REVISIONS	
(R)	REDLINE REVISION NO. 6-99 — INSTALL HB ALONG MD 45 NORTHBOUND REDLINE REVISION TO
(E)	11-20-98 ASBUILT SHA NO.: BA1655176
R.R.Z.	
D	4/96 RECONSTRUCT SIGNAL IN CONJUNCTION WITH STREETSCAPE PROJECT.

TRAFFIC ENGINEERING DESIGN DIVISION

MD 45 (YORK RD) @ PENNSYLVANIA AVE

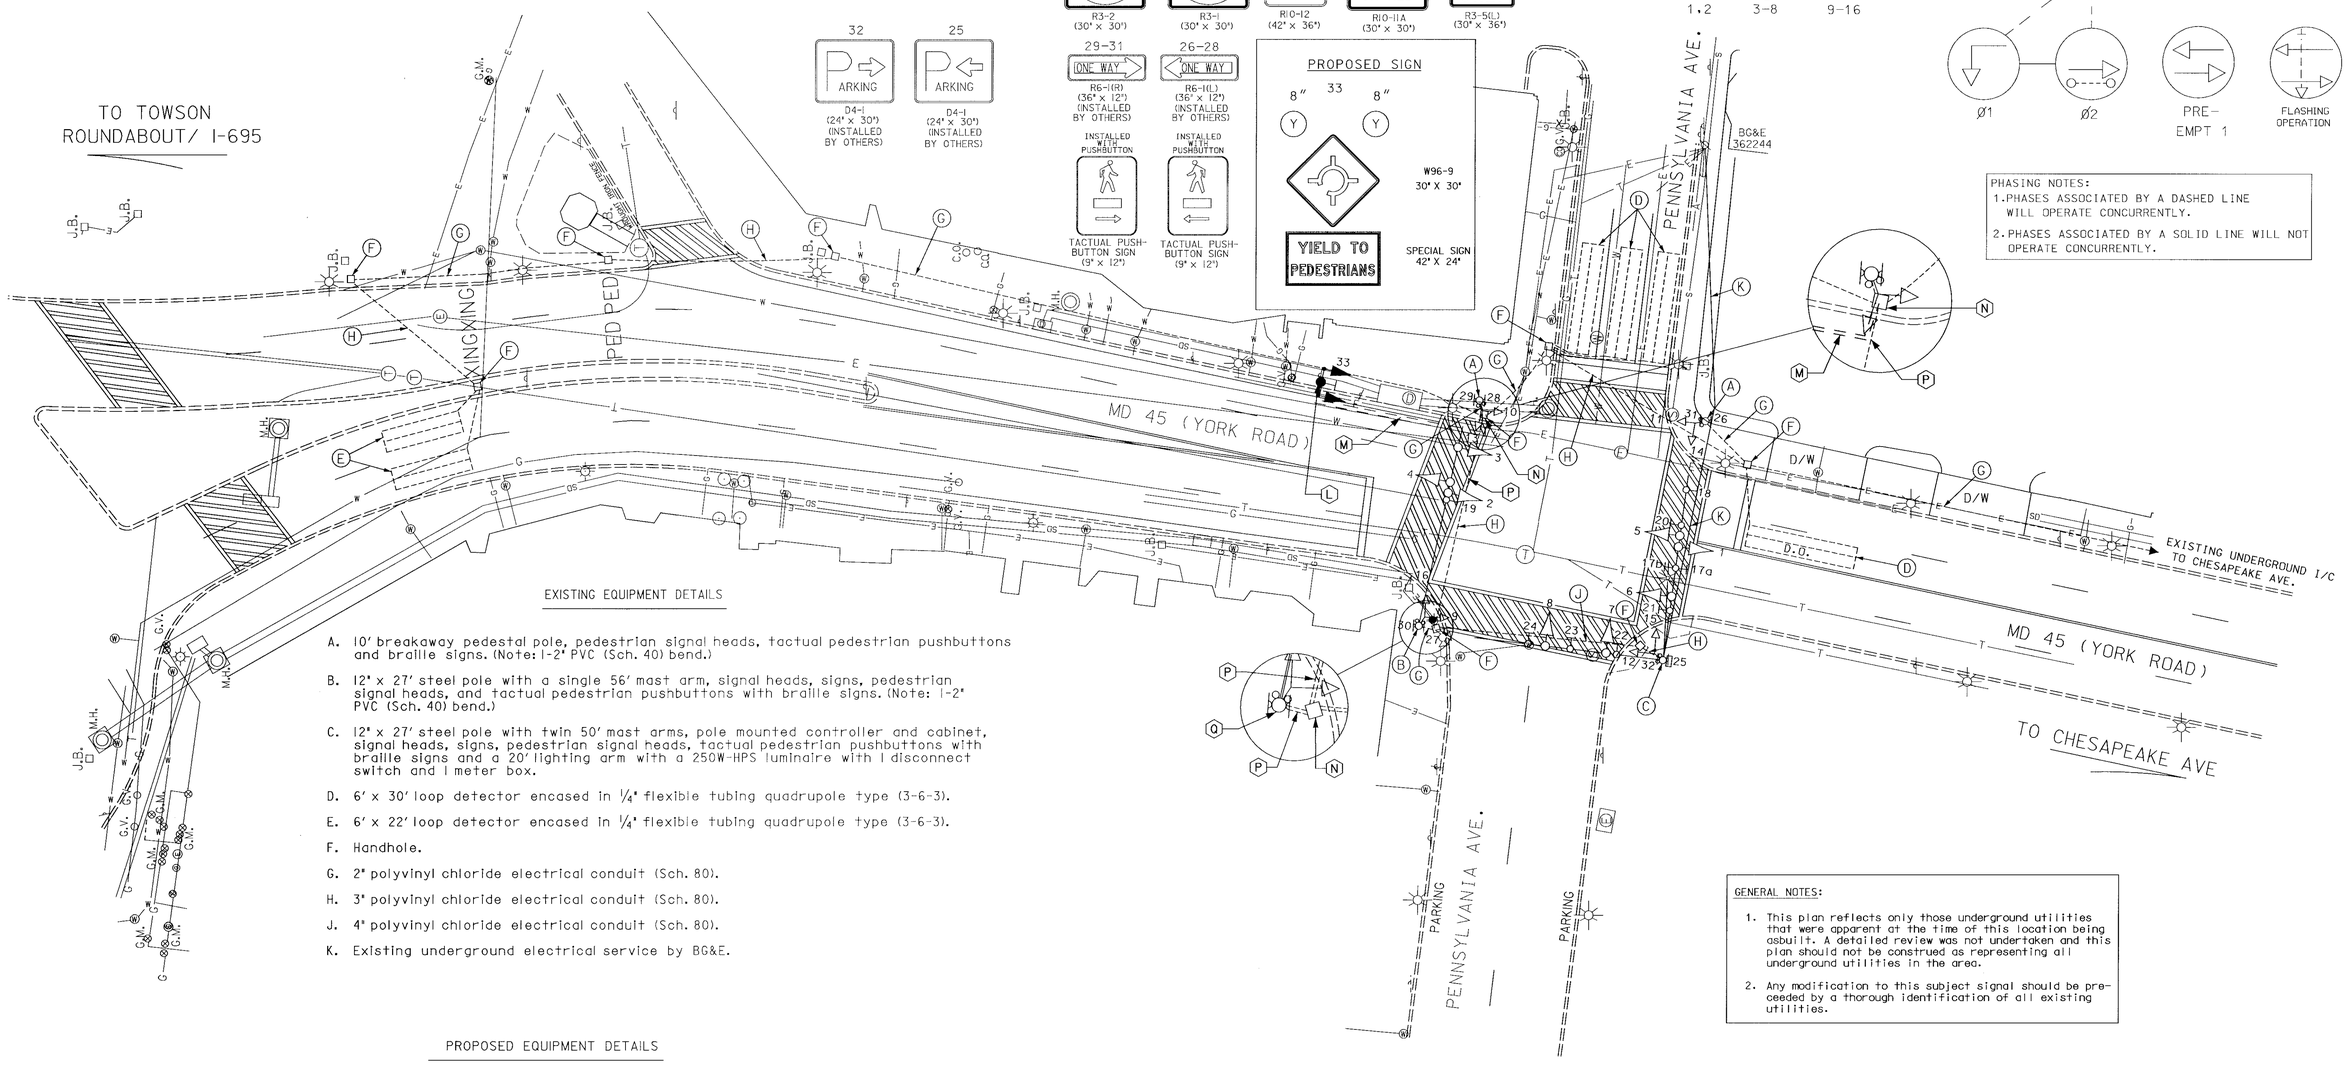
PROPOSED SIGN — 33 — 8" Y — 8" Y — W96-9 30" X 30" — YIELD TO PEDESTRIANS — SPECIAL SIGN 42" X 24"

L. Install a 14 foot pedestal pole with breakaway base support, signal heads, and signs as shown. (Note: one 2 inch PVC Sch. 80 conduit bend, four 1 inch x 40 inch anchor bolts. Also, install ground rod through pole foundation and remove existing ground mounted signs.)

M. Install 2 inch PVC Sch. 80 electrical conduit - slotted.

N. Use existing handhole.

P. Install 3 conductor electrical cable (No. 14 AWG) in existing conduit.

Q. Use existing conduit bend in pole foundation and pull cables to signal head No. 4. (Note: Contact SHA Signal Shop (Mr. Ed Rodenhizer at 410-787-7650) to install terminal block, connect spare wires in signal head and connect to new flasher unit in existing cabinet.
